Milwaukee Historic Preservation Commission

June 1, 2020

4 SECTION
1/2" = 1'-0"

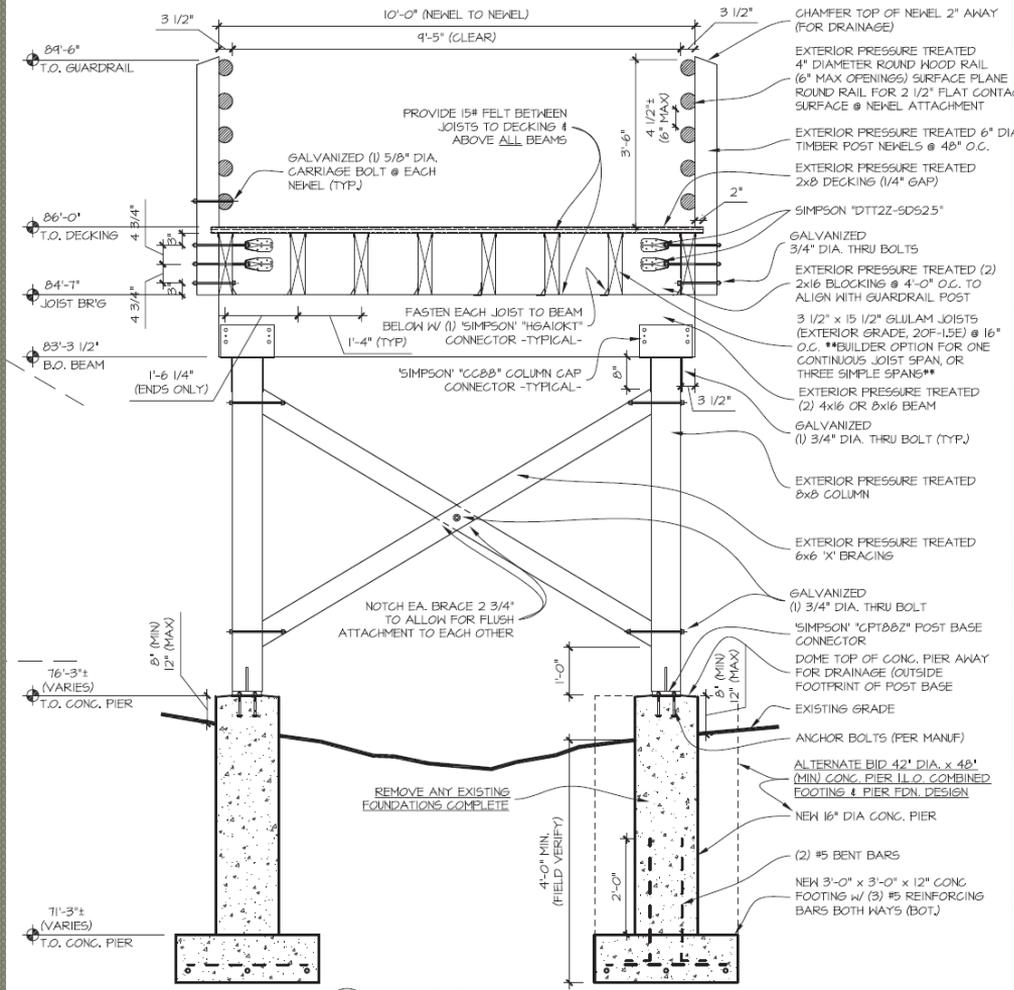
Approve with conditions

- ~~Wisconsin Historical Society review is required pursuant to Wis. Stats. §§ 44.42 and 66.1111. County must submit proof of WHS approval before the COA will be issued. On file~~
- Wood should be dry and pressure-treated material may not have a noticeable change in color from natural wood nor may show any of the incisions from the pressure-treating process. The typical green color of copper-based treatments is not appropriate.
- Provide material samples of wood components to staff for approval.
- Consider acetylated wood decking.

02 STOREFRONT ELEVATION SCALE - 1/2" = 1'-0"

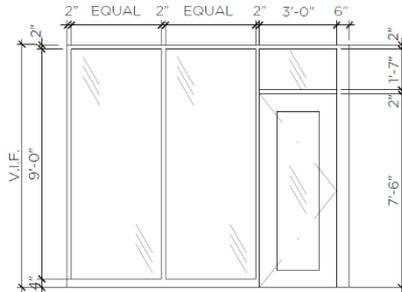
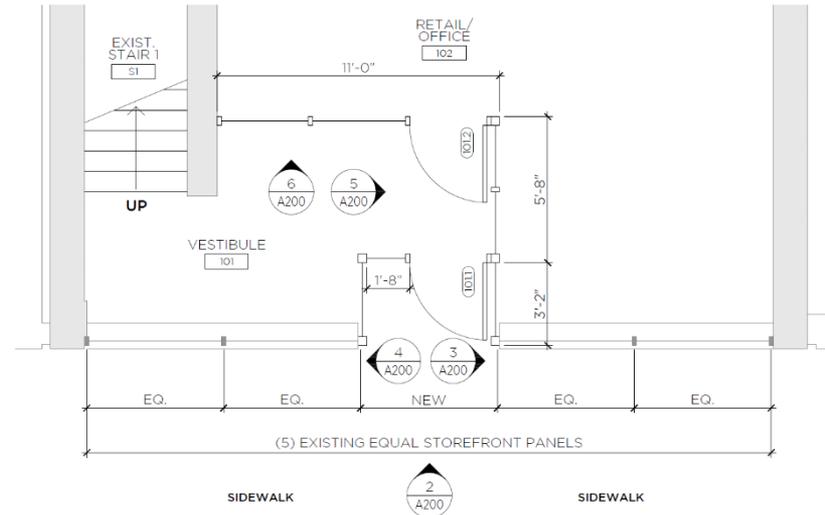
Rec: Approve with conditions

- Submit specific wood storm design for staff approval
- Consider centering new entry door
- Applicant cannot be present, requests HOLD if you do not agree with staff conditions.

FLOORPLAN SKETCH

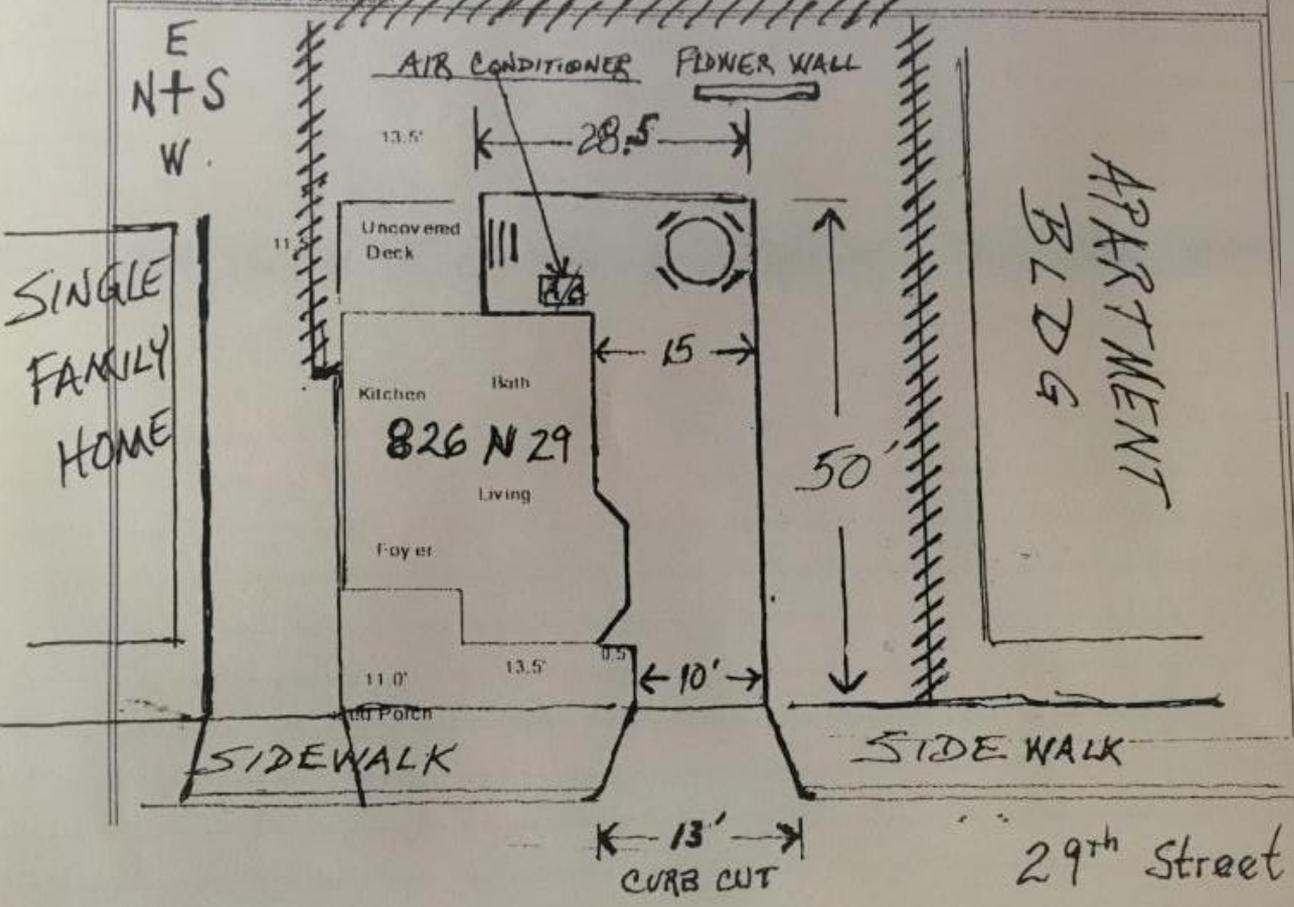
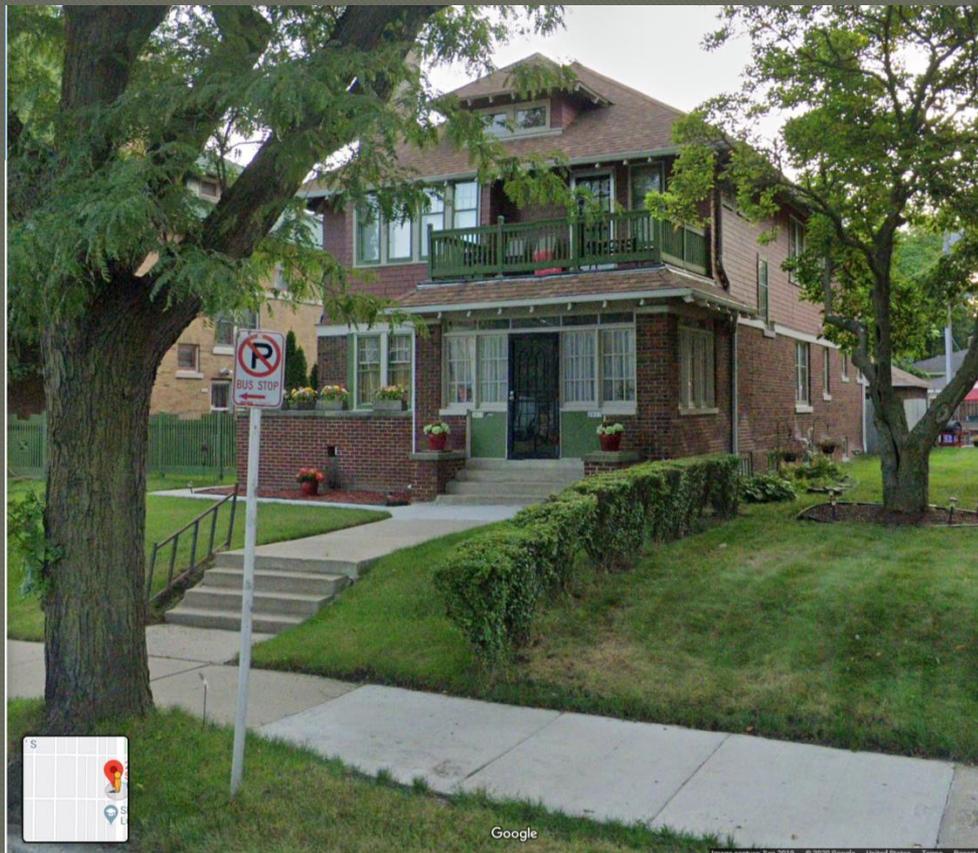
- Approve concrete work and a/c as proposed
- Hold garden wall for material info and design work

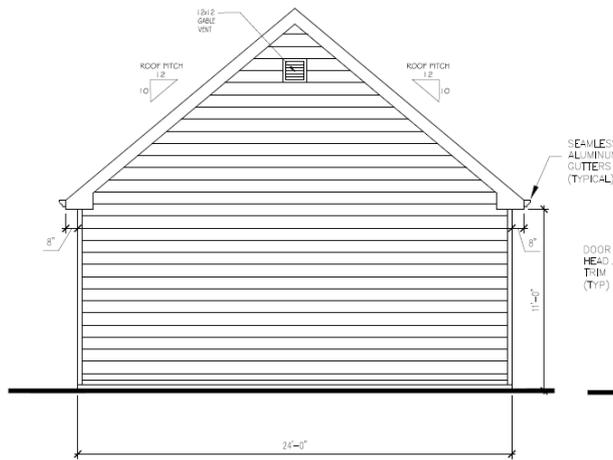
- Exterior mounted balusters not permitted
- Top rail itself must be the graspable surface
- Do not use interior handrail and brackets

- Approve with conditions
 - Keep posts
 - Replace railings with standard design
 - Paint all

4 LEFT ELEVATION
SCALE: 3/8" = 1'-0"

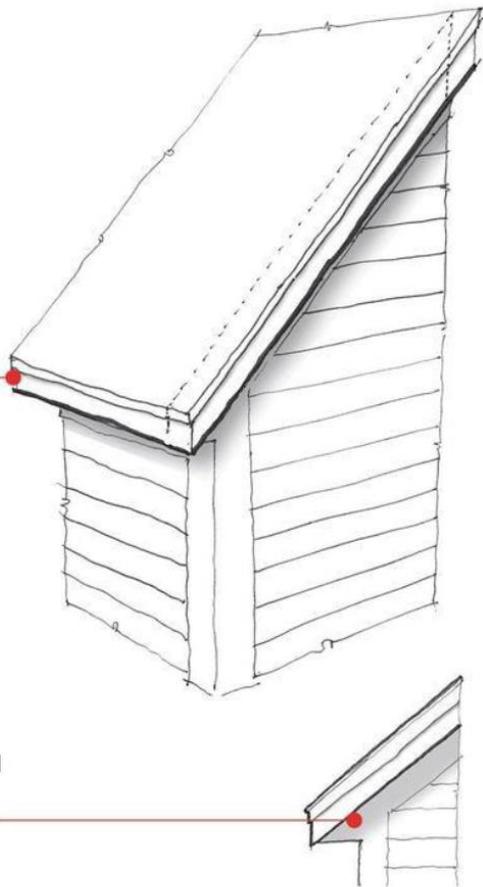
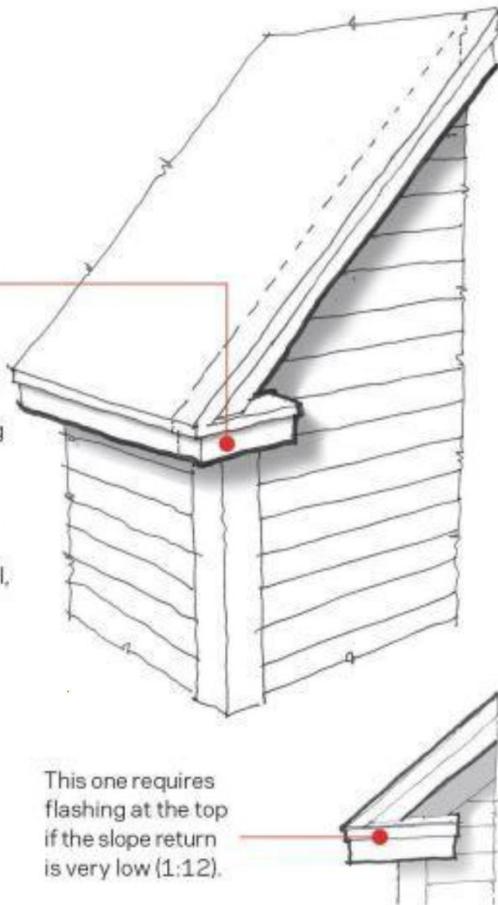
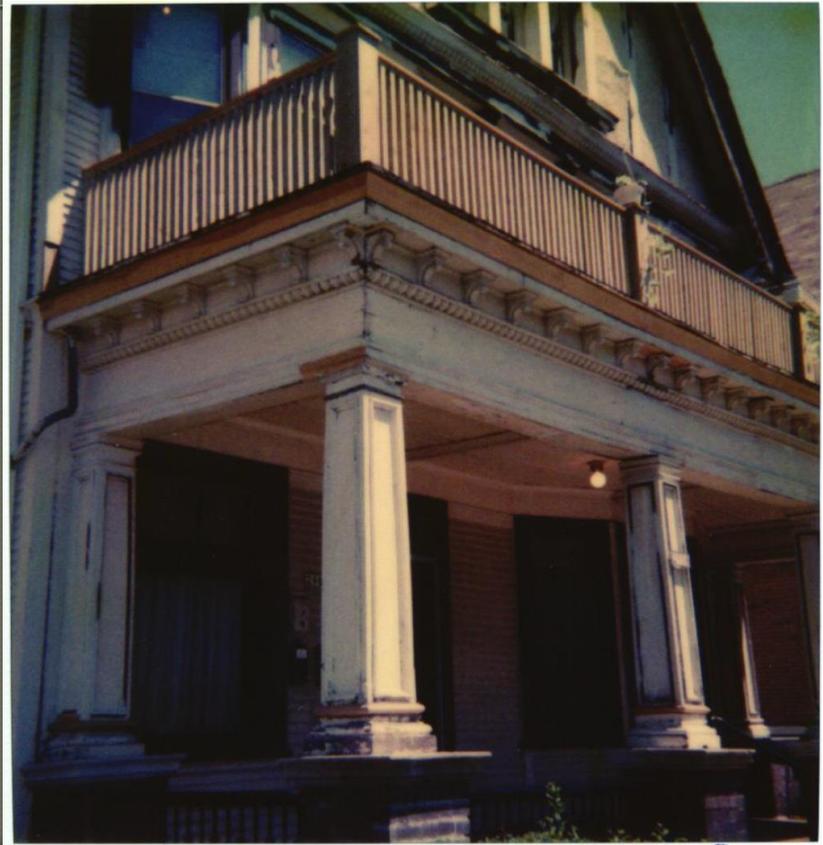
- As proposed with two conditions
 - Change eave return detail
 - Larger gable vent
